# PLANNING COMMISSION STAFF REPORT

## WINEMILLER LANE EXTENSION AND CUL-DE-SAC - DEDICATION PLAT

RE: Winemiller Lane Extension  
Construction Plan Review  
Batavia Township

## Dedication Plat Winemiller Lane Temple's Military Survey No. 4459 Batavia Township, Clermont County, Ohio

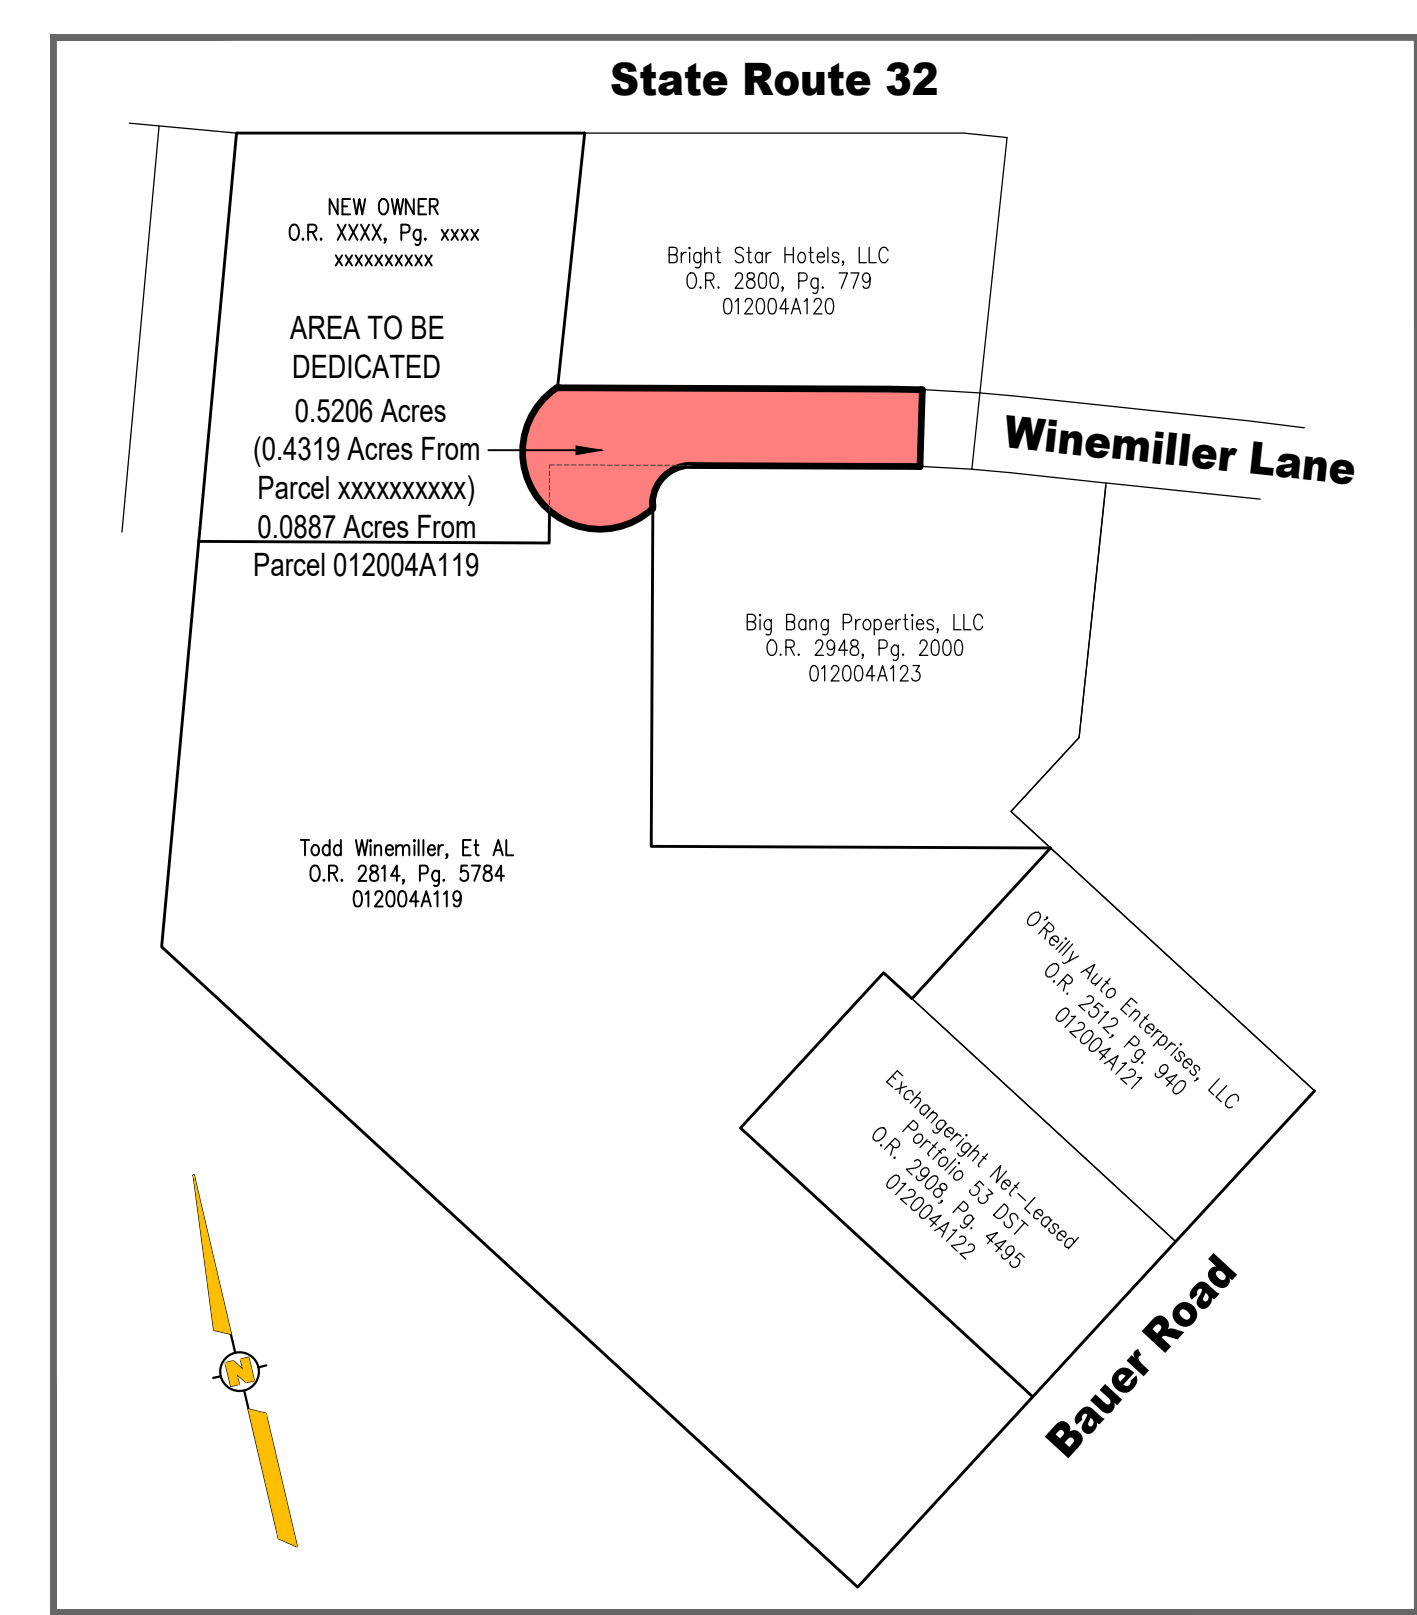
- 3 C-1 The North and South Limits of the proposed Right-of-Way differ from the surveys of record, dated: 1-20-2003 and 5-10-2023. The dimensions of the proposed Winemiller Road need to reflect the property lines of record.

- 5 C-1/C-3 The Right-of-Way for the proposed Winemiller Cul-De-Sac needs to be adjusted. The Northeast starting point needs to start with a PT/PC at the Southwest corner of Parcel No. 01-20-04A-120. The Southern limit of the Cul-De-Sac Right-of-Way needs to be tangent to the proposed Cul-De-Sac Right-of-Way Radius and be perpendicular to the West property line of Parcel No. 01-20-04A-123. The location of the Cul-De-Sac pavement will need to be adjusted and the associated road extended. The Center of the Cul-De-Sac Pavement and Right-of-Way need to align.

- 6 C-1/C-3 The centerline for the proposed Winemiller Road Extension needs to be offset by Thirty (30) Feet from the corrected South Property line along for Parcel Number 01-20-04A-120. Be sure to note the centerline curve data (Delta, Radius, Length, Chord Length, and Chord Bearing) upon the plans.
